#### Bid Bulletin No. 5 February 16, 2021

### Public Bidding No. 21-005-8

# CONSTRUCTION of COMMAND CENTER BUILDING for the OFFICE FOR TRANSPORTATION SECURITY

# Annex "A"

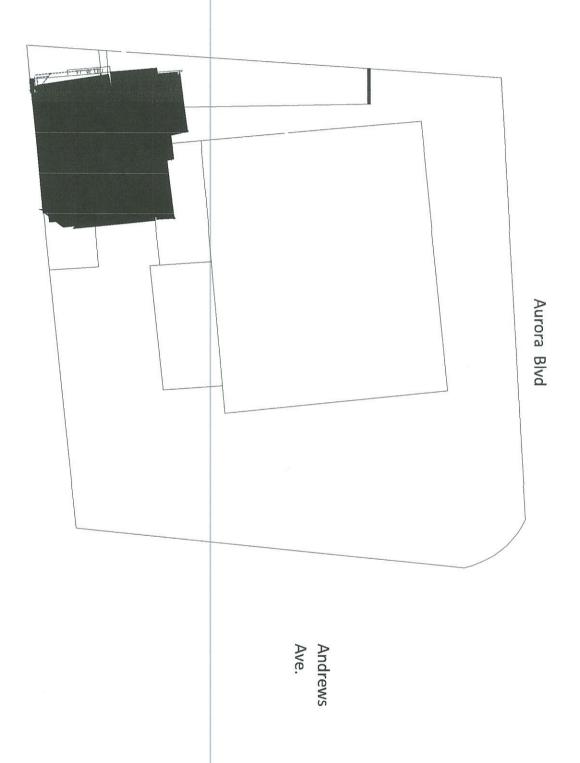
try to the site. All th and safety protocols			
SECTION III. BID DATA SHEET <sup>1</sup> Clause 20.2 Page 22			
7. For all items requiring UL and CE certification, bidder must submit manufacturer's certification that the items offered are UL and-CE Certified			
SECTION VII. DRAWINGS			
	To correct site location of the proposed building (see		
	attached Annex "A")		
	th and safety protocols  TA SHEET <sup>1</sup> and CE certification, facturer's certification L and-CE Certified
